COUNCIL ASSESSMENT REPORT

SYDNEY NORTH PLANNING PANEL

PANEL REFERENCE & DA NUMBER	PPSSNH-242 - DA/484/2011/J
PROPOSAL	Section 4.56 Modifications to internal road design, community centre design, signage and conditions of development consent.
ADDRESS	392 Galston Road (Lot 1 DP 1211969)
APPLICANT	Vigor Master
OWNER	392 Galston Investment Pty Ltd
DA LODGEMENT DATE	1 July 2021
APPLICATION TYPE	Section 4.56 Modification
REGIONALLY SIGNIFICANT CRITERIA	Section 4.56 Modification
CIV	\$23,792,750.00
CLAUSE 4.6 REQUESTS	N/A
KEY SEPP/LEP	<ul style="list-style-type: none"> • <i>State Environmental Planning Policy No. 55 Remediation of Land</i> • <i>State Environmental Planning Policy (State and Regional Development) 2011</i> • <i>State Environmental Planning Policy (Infrastructure) 2007</i> • <i>State Environmental Planning Policy (Housing for Seniors or People with a Disability) 2004</i> • <i>Hornsby Local Environmental Plan 2013</i>
TOTAL & UNIQUE SUBMISSIONS KEY ISSUES IN SUBMISSIONS	1/1

Figure 3: Proposed Signage

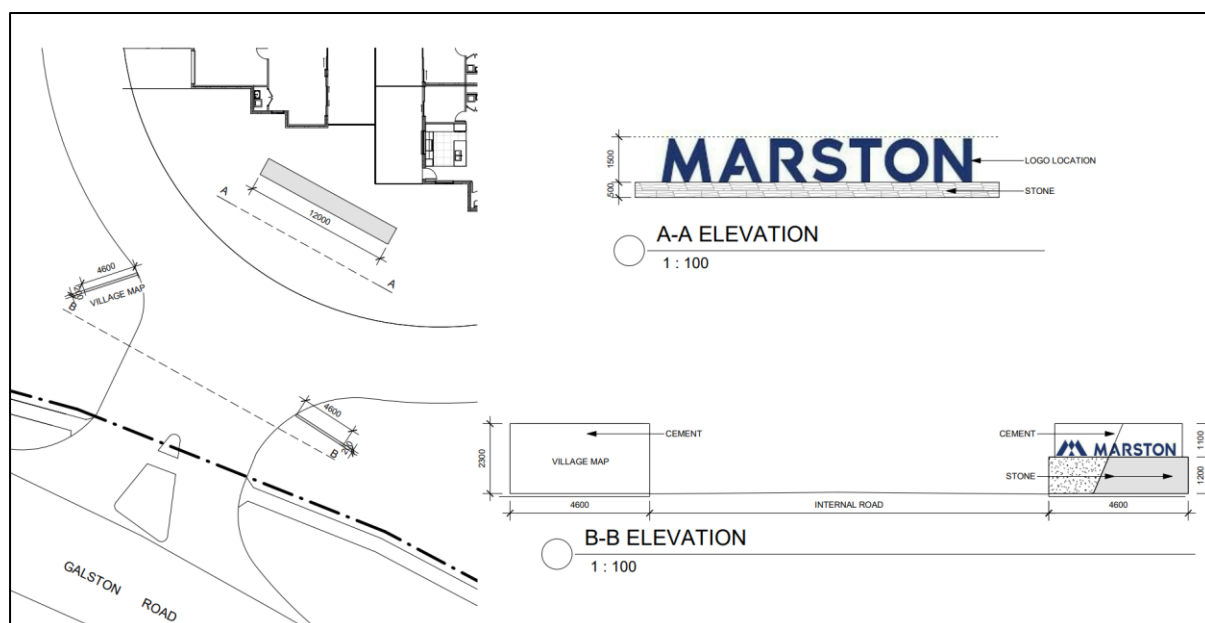
The signage would be located facing the Galston Road frontage, as depicted in Figure 3 below.

The proposed signs have been assessed against the requirements of *State Environmental Planning Policy No. 64 – Advertising and Signage (SEPP 64)*. This Policy provides State-wide planning controls for advertising signs and prevails over other environmental planning instruments including the HLEP and the Hornsby Development Control Plan 2013. The aims of the Policy are to ensure that advertising and signage is compatible with the desired amenity and visual character of an area, to provide effective communication in suitable locations and to ensure signage is of high-quality design and finish. The proposed signs are identified as ‘business identification signs’ as defined under *SEPP 64*.

Figure 4: Extract showing proposed staging and modifications bubbled in Red.

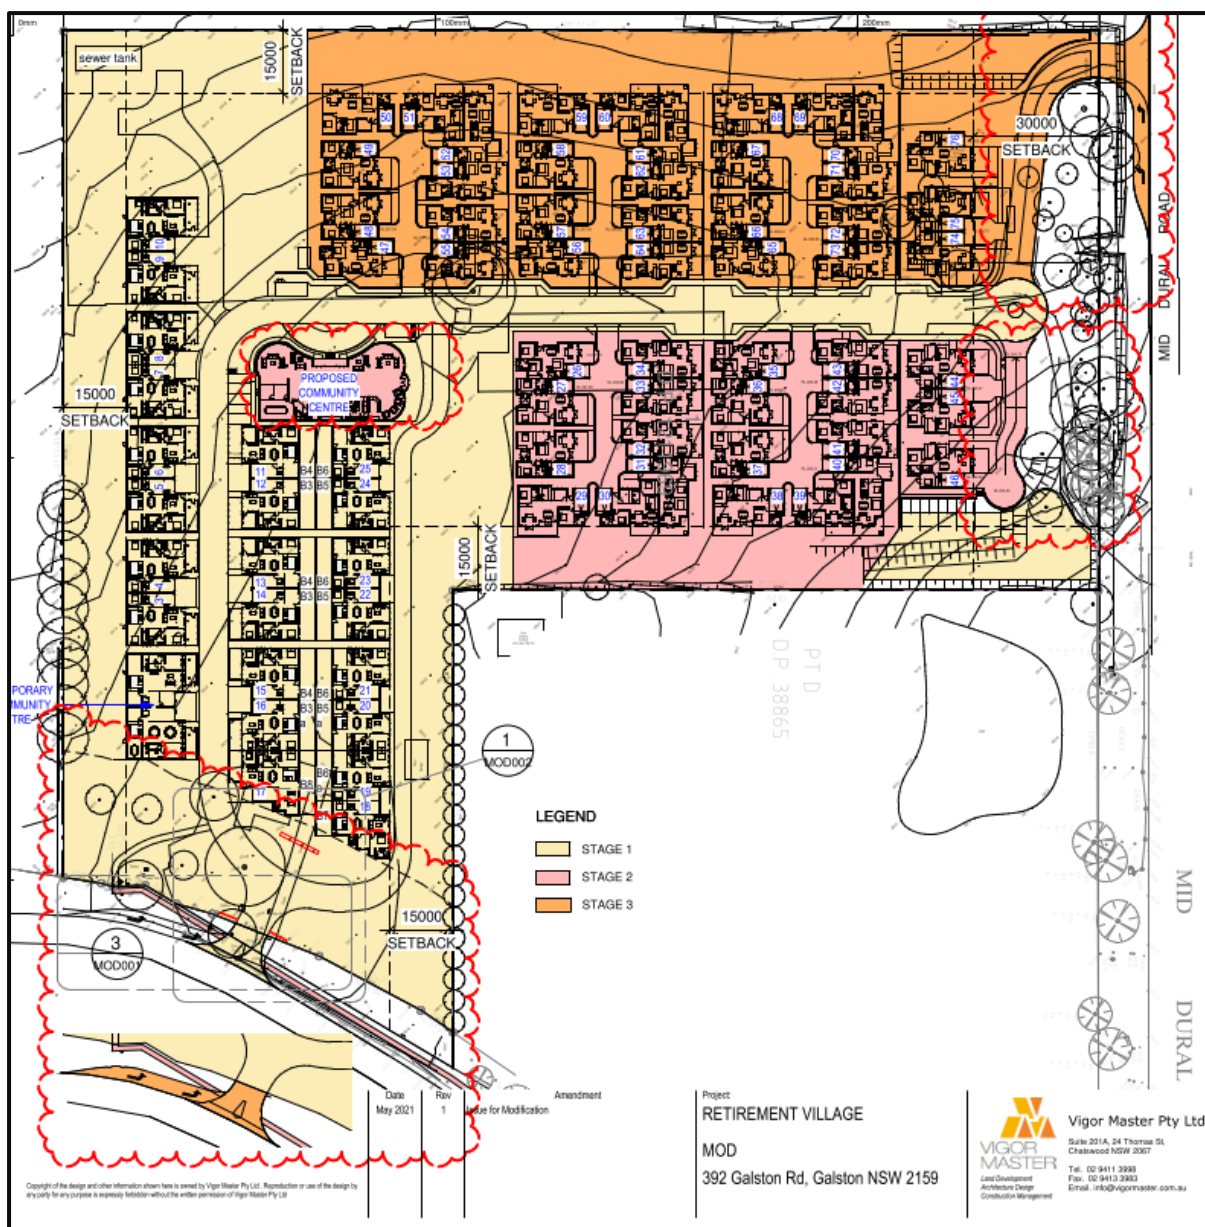
The adjustments proposed to the internal roads are the turning radius of each road at the intersection near the Galston Road village entrance and the alignment of the section of the road to the north of the permanent community centre.

Transport for New South Wales (TfNSW) reviewed the proposed modifications under Section 138 of the *Roads Act 1993*. TfNSW provided three requests for additional detail to the applicant in response to the proposed updated intersection design, and the existence of the temporary unauthorised crossing that was constructed during 2021. In addition to these requests, a meeting was held on 30 November 2021 between TfNSW representatives, Council staff and the applicant to discuss the path forward for the proposed design and retrospective approval for the unauthorised constructed crossing.

The applicant has provided information in response to the TfNSW requirements following each request from the agency, however was unable to satisfy the requirements. On 22 February 2022, Transport for New South Wales provided an additional response that outlined that they were unable to support the unauthorised crossing or the ultimate intersection design and requested further detail be provided.
